Access Audit Site Report

South Llano River State Park
1927 Park Rd 73
Junction, TX 76849
Accessibility Evaluation
Inspection Date: 07/28/2022
Inspectors: Tanya Scheibe

Prepared By
WT Group

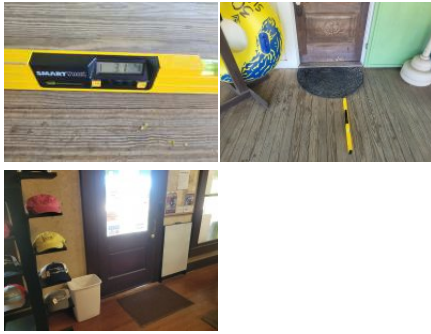
4	Headquarters Area: HQ - Parking	[30.4457036, -99.8041842]	The parking stall contains abrupt edges and surface irregularities over a 1/4 inch vertical. Parking spaces and access aisles serving them shall be stable, firm, and slip resistant. Access aisles shall be at the same level as the parking spaces they serve. Changes in level are not permitted and shall not be sloped steeper than 2% in any direction.	Loose gravel in stalls and access aisle, CIL at ramp	Resurface stalls and access aisles to eliminate loose gravel. Remove built up ramp in access aisle.	2015 ABAAS Section: 502.4 2012 TAS Section: 502.4 2010 ADAS Section: 502.4

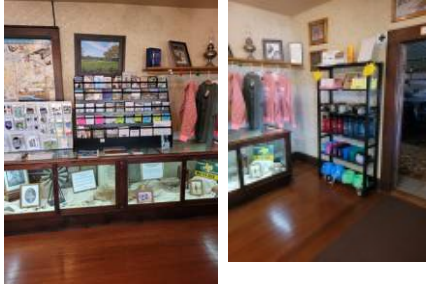
Finding Number	Area Description	Lat/Long	Finding	As Built	Recommendation	Citation	Photos	Figure
8	Headquarters Area: HQ - Exterior Accessible Route	[30.4456203, -99.8041962]	Visual characters shall be 40 inches (1015 mm) minimum above the finish floor or ground. EXCEPTION: Visual characters indicating elevator car controls shall not be required to comply with 703.5.6.	Turkey signage below 40"	Remount signage to min 40" AFF as a smart practice.	2015 ABAAS Section: 703.5.6, 703.5.6 EXCEPTION 2012 TAS Section: 703.5.6, 703.5.6 Exception 2010 ADAS Section: 703.5.6, 703.5.6 Exception		
9	Headquarters Area: HQ - Exterior Accessible Route	[30.44567, -99.80417]	Element meets all standards and requirements	Garbage can complies	None	2010 ADAS Section: N/A		
10	Headquarters Area: HQ - Exterior Accessible Route	[30.4455116, -99.8041043]	At least one accessible route shall connect accessible buildings, accessible facilities, accessible elements, and accessible spaces that are on the same site. For areas of sport activity, an accessible route is required to connect to the boundary of each area of sport activity. The size of an area of sport activity includes only the space needed to play. Where multiple sports fields or courts are provided, an accessible route is required to each field or area of sport activity.	Lacks route to bike rack	Relocate bike rack to be on the accessible route.	2010 ADAS Section: 206.2.2, 206.2

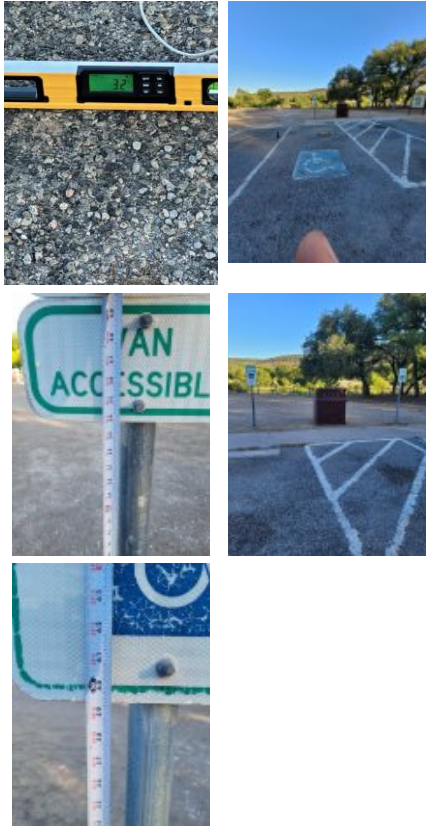
29	Headquarters Area: HQ - Restroom	[30.4454249 , -99.804106 4]	The restroom is not compliant. The restroom does not have the required minimum clear floor space or maneuvering clearances for the toilet. The restroom does not have the required minimum clear floor space or maneuvering clearances for the lavatory. The entry door does not contain the required minimum maneuvering spaces on the pull/push sides. The entry door encroach into the required clear floor space for fixtures. Grab bars are missing and/or incorrectly installed. Accessories, such as toilet seat covers, paper towel holders, garbage cans, hand dryers, and mirrors are either too high or without clear floor space or both.	Lacks accessible features and signage	Create a compliant wheelchair accessible restroom and correct all features to be accessible if feasible. Mount directional signage to an accessible restroom until renovations occur.	2015 ABAAS Section: 603.1 2012 TAS Section: 603.1 2010 ADAS Section: 603.1

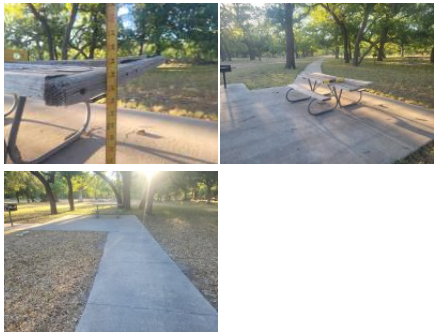
35	Day Use Area: Day Use - Parking	[30.4492229 , -99.809553 9]	The parking stall contains abrupt edges and surface irregularities over a 1/4 inch vertical. Parking spaces and access aisles serving them shall be stable, firm, and slip resistant. Access aisles shall be at the same level as the parking spaces they serve. Changes in level are not permitted and shall not be sloped steeper than 2% in any direction.	Day Use - Loose gravel in stalls and access aisle	Resurface accessible stalls and access aisles with a firm, stable, and slip resistant material.	2015 ABAAS Section: 502.4 2012 TAS Section: 502.4 2010 ADAS Section: 502.4		
36	Day Use Area: Day Use - Parking	[30.4492345 , -99.809532 5]	The parking stall contains abrupt edges and surface irregularities over a 1/4 inch vertical. Parking spaces and access aisles serving them shall be stable, firm, and slip resistant. Access aisles shall be at the same level as the parking spaces they serve. Changes in level are not permitted and shall not be sloped steeper than 2% in any direction.	3 accessible stalls and both access aisles have loose gravel at day use restroom	Resurface accessible stalls and access aisles with a firm, stable, and slip resistant material.	2015 ABAAS Section: 502.4 2012 TAS Section: 502.4 2010 ADAS Section: 502.4

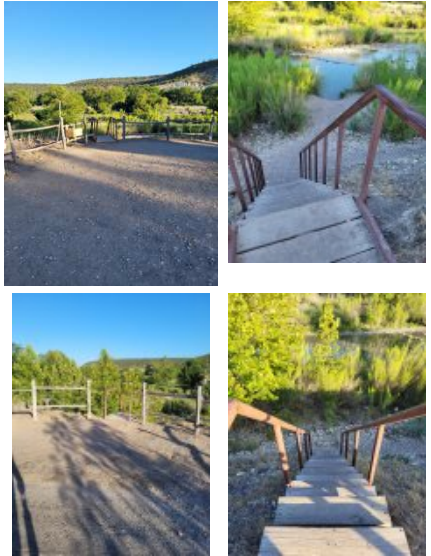
48	Day Use Area: Day Use - Shelter/Picnic Area	[30.4482518 , -99.810015 3]	Where picnic facilities contain two or fewer picnic units, each picnic unit shall provide mobility features complying with F245.2.	1 of 4 garbage cans on AR, picnic areas spread out and garbage cans at each should be reachable	Relocate garbage along accessible route in picnic area.	2015 ABAAS Section: F245.2.1		
49	Day Use Area: Day Use - Shelter/Picnic Area	[30.4497384 , -99.809601 2]	The accessible route of travel contains cross slopes greater than 2%. Cross slopes shall not exceed one unit vertical in 48 units horizontal (2-percent slope).	2.4% near metal garbage cans	Correct or repair cross slope along AR to max 2.08%. In the alternative, leave as is citing construction tolerance.	2015 ABAAS Section: 403.3 2012 TAS Section: 403.3 2010 ADAS Section: 403.3

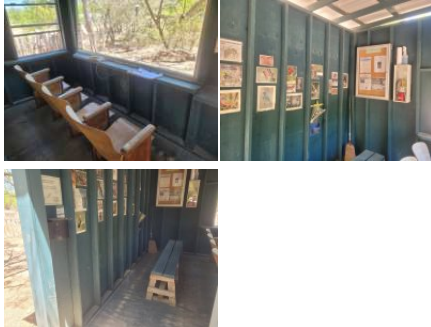
65	Day Use Area: Day Use - Women's Restroom	[30.4481916 , -99.809277 7]	The grab bar height and/or spacing fails. Grab bars must be mounted between 33" and 36" to the top of the gripping surface. There must be 1.5" of clearance between the grab bar and the wall. There must be a minimum of 1.5" of clearance below and minimum 12" above the grab bar to any dispenser or other obstruction.	Rear bar 38.5"	Remount grab bars in accessible stall to 33" to 36" above the finished floor (AFF).	2015 ABAAS Section: 609.3, 609.4 2012 TAS Section: 609.4, 609.3 2010 ADAS Section: 609.3, 609.4

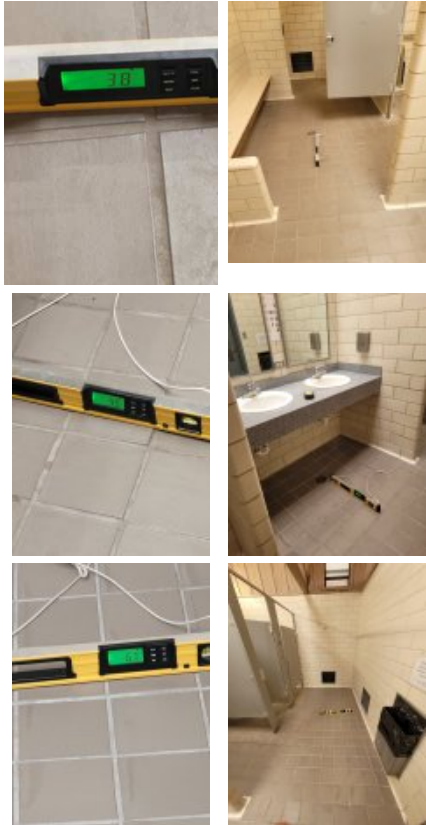
104	Camping Area: Campground - Men's Restroom	[30.4467996 , -99.799243 5]	The bench is not deep enough or long enough or is missing. Benches shall be provided having seats that are 42 inches long minimum and 20 inches deep minimum and 24 inches deep maximum. The bench shall provide for back support or shall be affixed to a wall. Back support shall be 42 inches (1065 mm) long minimum and shall extend from a point 2 inches (51 mm) maximum above the seat surface to a point 18 inches (455 mm) minimum above the seat surface. Back support shall be 2½ inches (64 mm) maximum from the rear edge of the seat measured horizontally. The top of the bench seat surface shall be 17 inches (430 mm) minimum and 19 inches (485 mm) maximum above the finish floor or ground. Clear floor or ground space complying with 305 shall be provided and shall be positioned at the end of the bench seat and parallel to the short axis of the bench	12" seat depth at bench	Replace bench in dressing area with one having a seat depth of 20" to 24" deep, 42" long, affixed to the wall or having a back and mounted 17" to 19" aff and provide required clear floor space on the short axis of the bench.	2012 TAS Section: 903.4, 903.2, 903.3, 903.5 2010 ADAS Section: 903.4, 903.2, 903.3, 903.5
